## ORIGINATION FORM

Proposed Revisions to a Standard Plans Index  
(Please provide all information — Incomplete forms will be returned)

Index Number: 102-615  
Sheet Number (s): 1 and 4 of 5  
Index Title: Multilane Roadway, Intersection Work

SHEET  
4 of 5

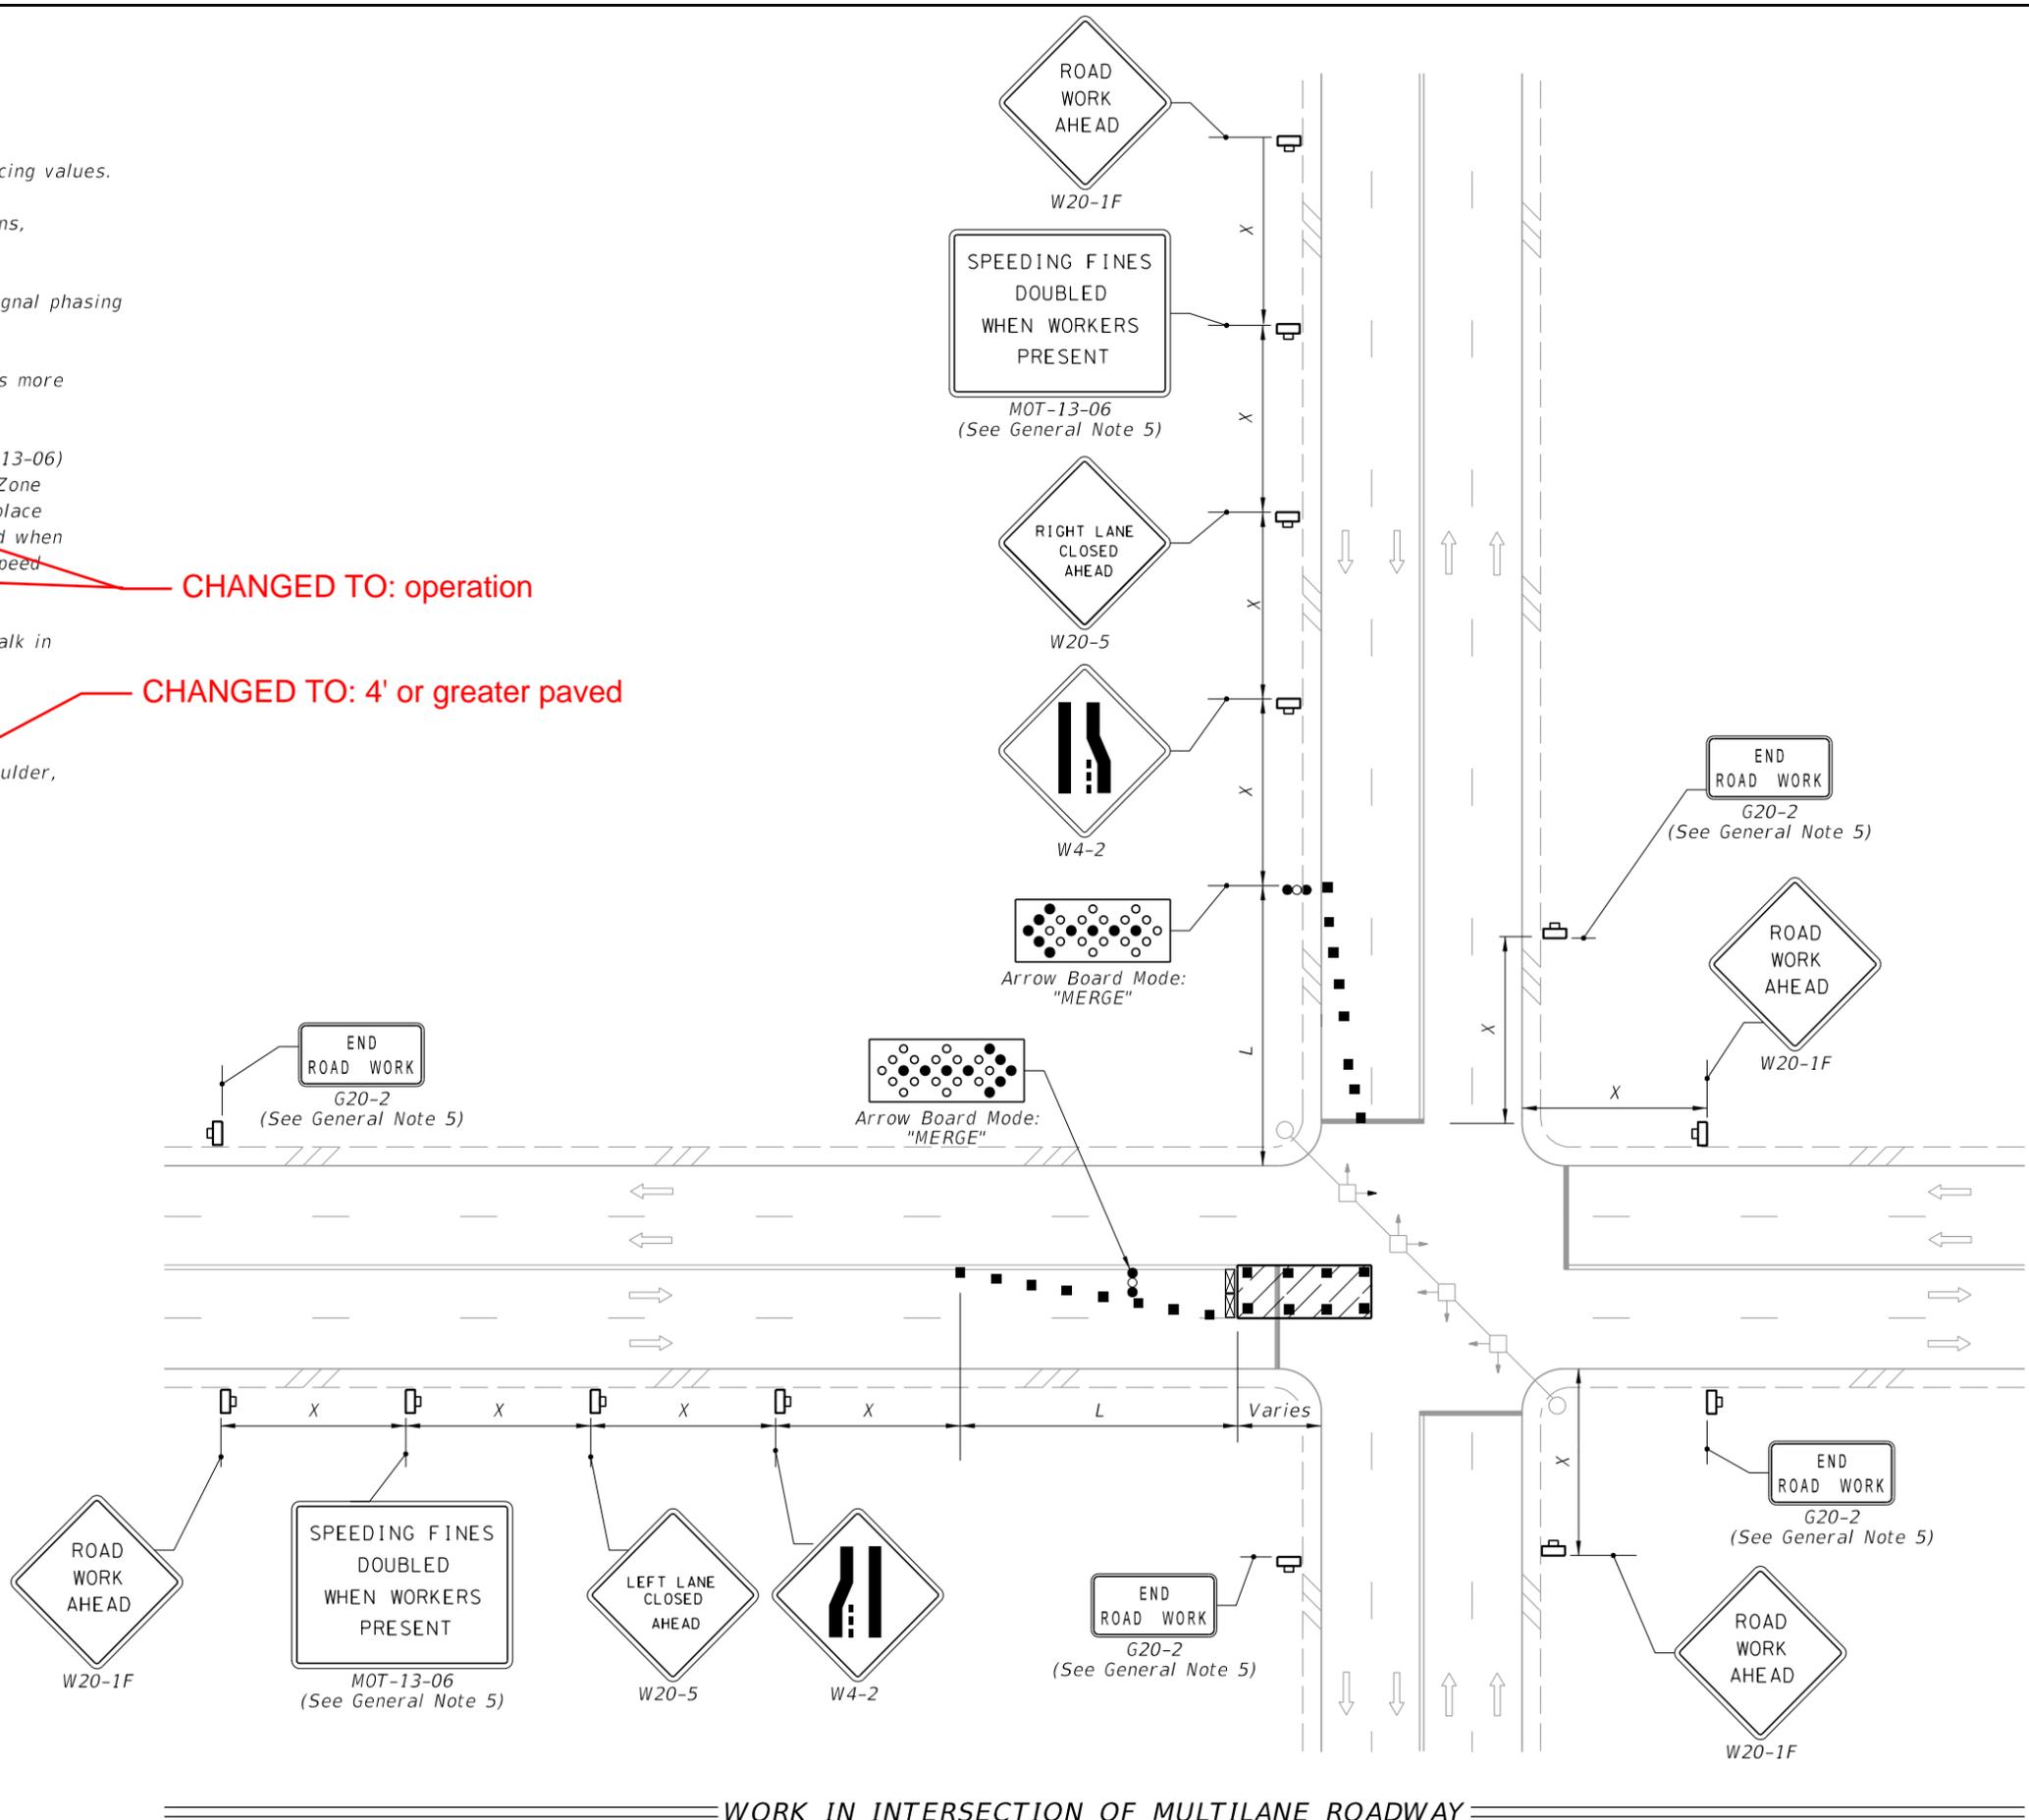
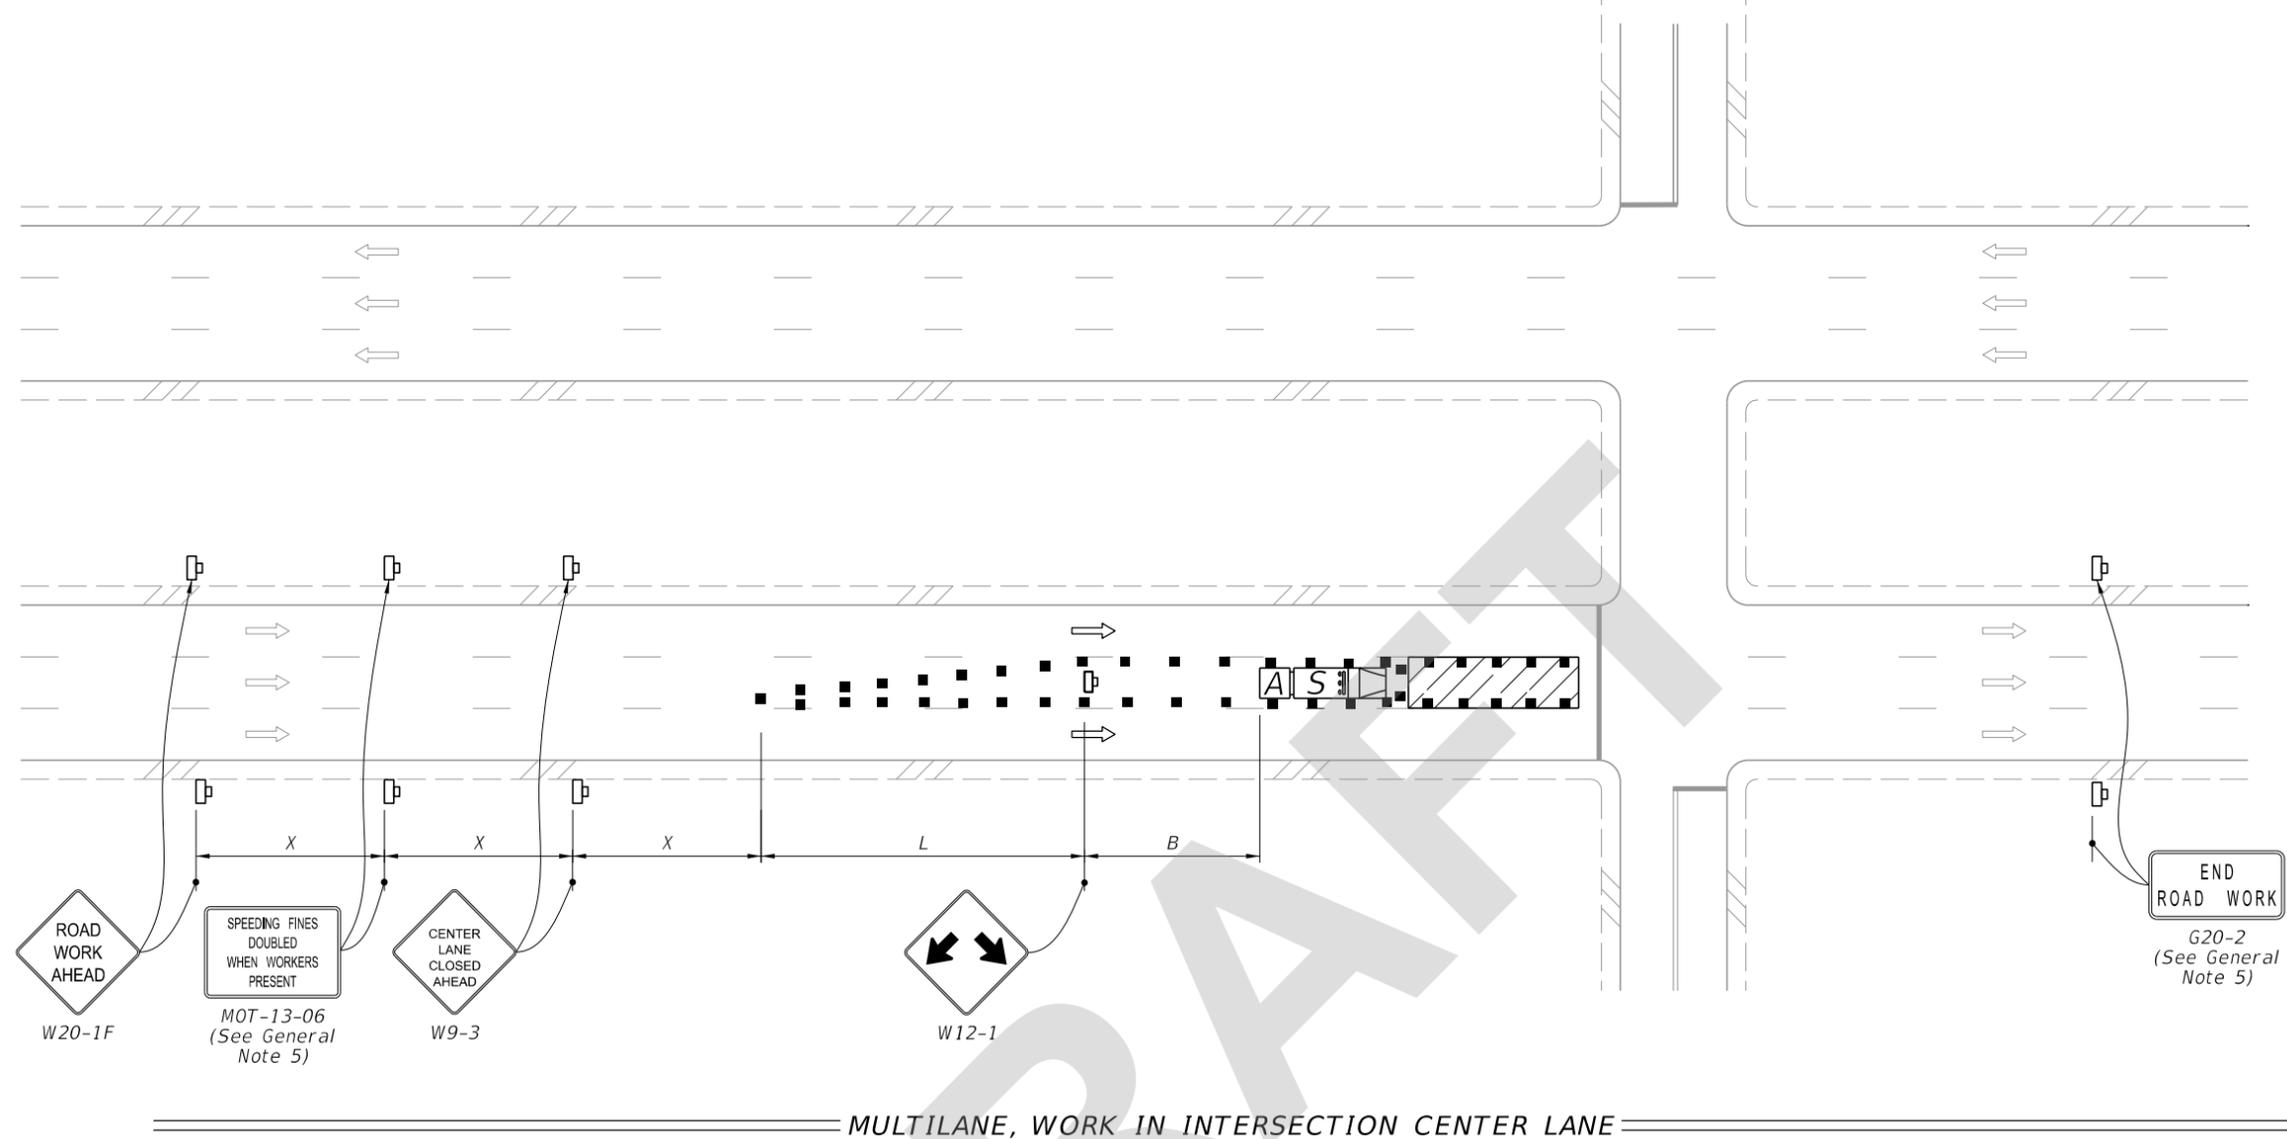
Sheet 4: Moved buffer zone and the associated dimension "B" before the Truck Mounted Attenuator in the work zone.

The buffer space was moved to be consistent with the MUTCD. MUTCD guidance says "When a shadow vehicle, arrow board, or changeable message sign is placed in a closed lane in advance of a work space, only the area upstream of the vehicle, arrow board, or changeable message sign constitutes the buffer space."
